**PLAN COMMISSION MEETING
IN PERSON AND VIA ZOOM
TUESDAY, APRIL 23, 2024 – 4:00 PM
CITY HALL – SECOND FLOOR**

SITE PLAN AND CONDITIONAL USE PERMIT REPORT TO THE PLAN COMMISSION

FILE NUMBER: CUP-2024-01

REQUESTED USES: Wireless Communication
Tower

ACCESS DRIVEWAY @ STREET DETAIL

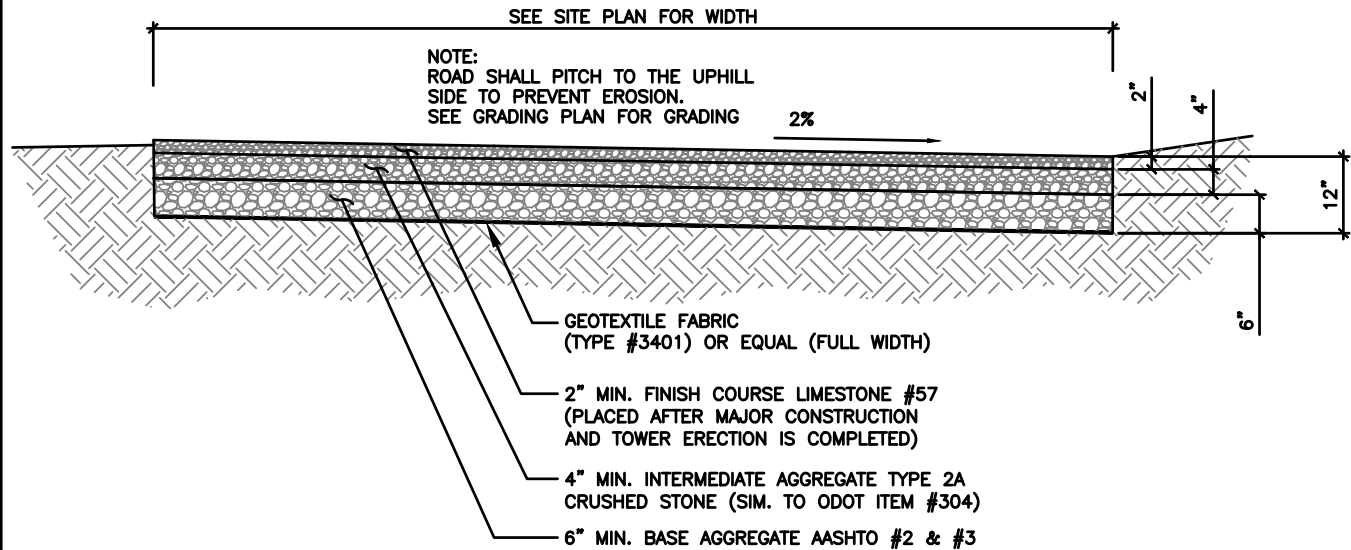
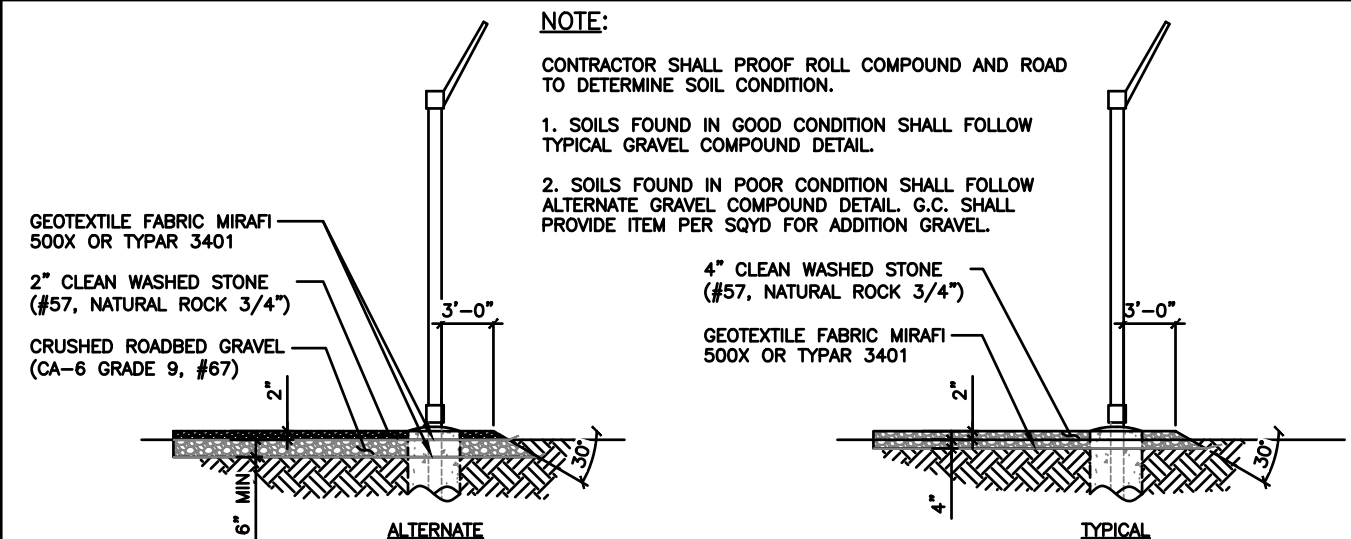
- All access points, drive isles, driveways, and parking areas must be constructed of a hard surface = **not met**
- Curbs are required adjacent to buildings, planting islands, required front yards, and to prevent vehicles from extending over pedestrian paths or right-of-way = **not met**

SHEET TITLE
GRADING
PLAN

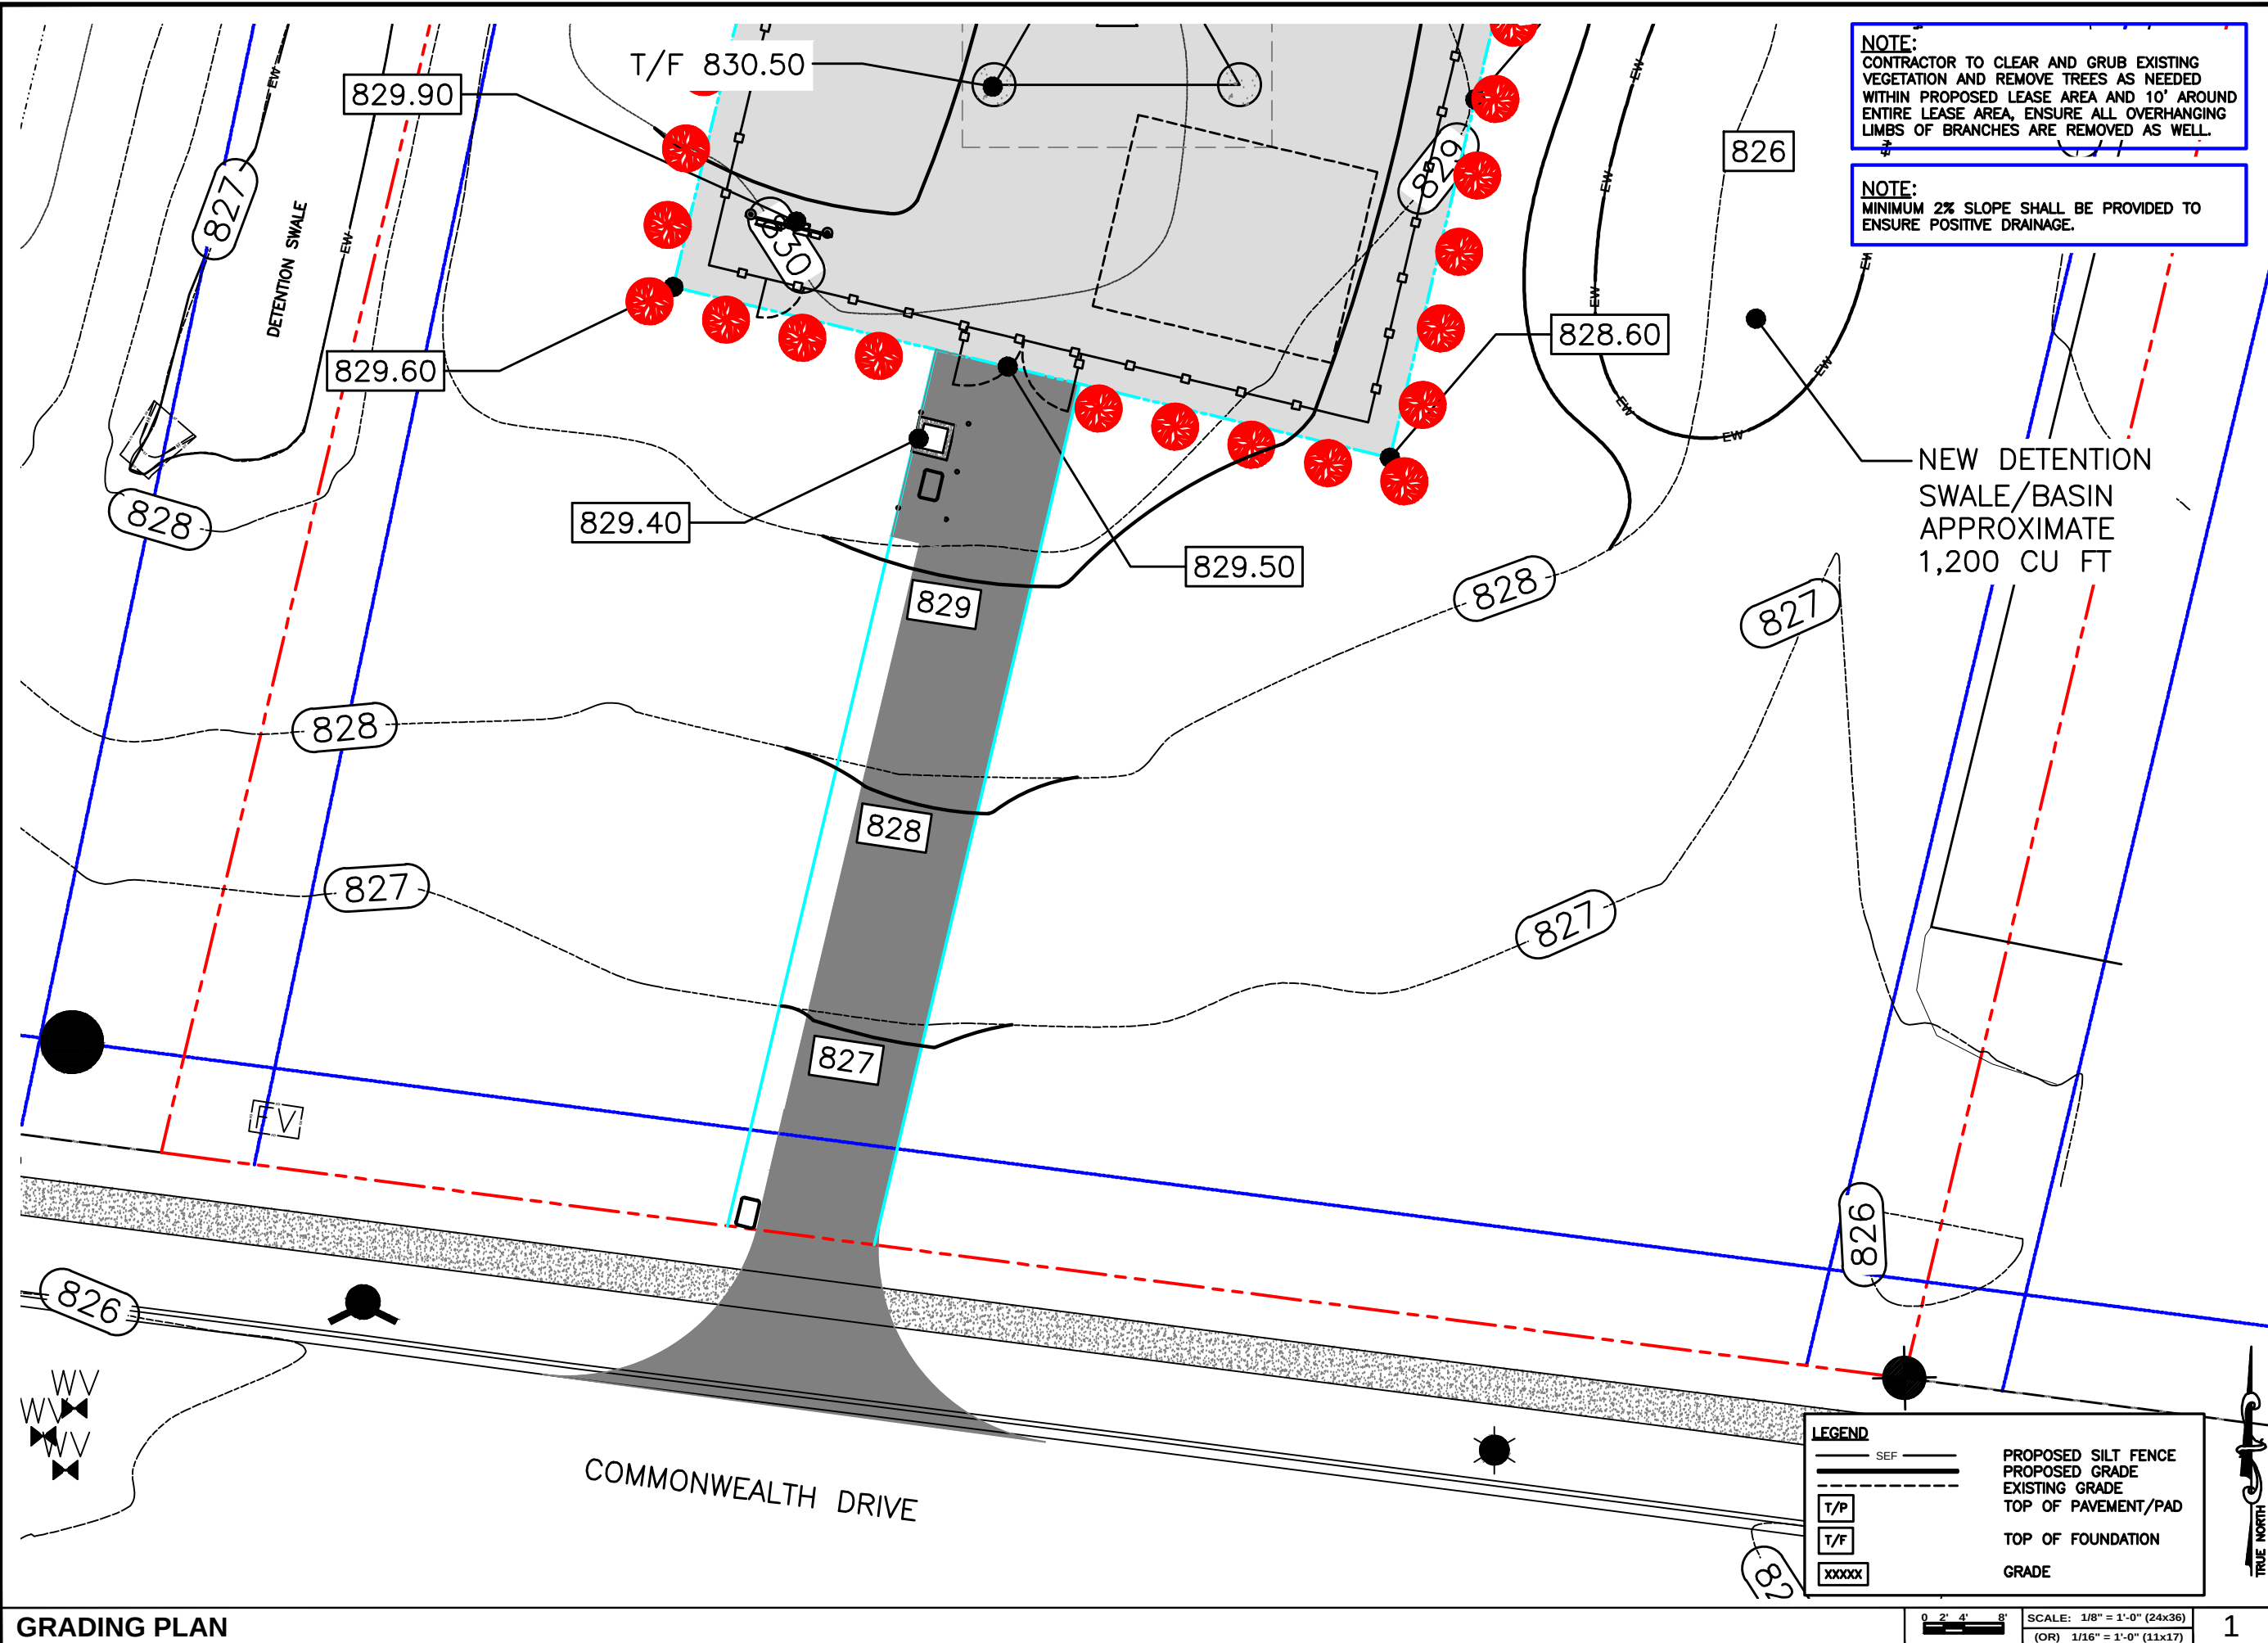
- Best Management Practices (BMP) that reduce the sediment load of stormwater runoff by a minimum of 80% = N/A
- Written Erosion Control Plan = met
- Prevent tracking of sediment off-site by equipment = **not met**
- Protect catch basins that take sediment laden stormwater into local rivers = **not met**
- Prevent the discharge of sediment as part of site dewatering = **not met**

The plan should add a stabilized construction entrance and detail, inlet protection for the nearest receiving catch basin the right of way, note the location of silt fence on the grading plan, and provide a dewatering detail for use if needed.
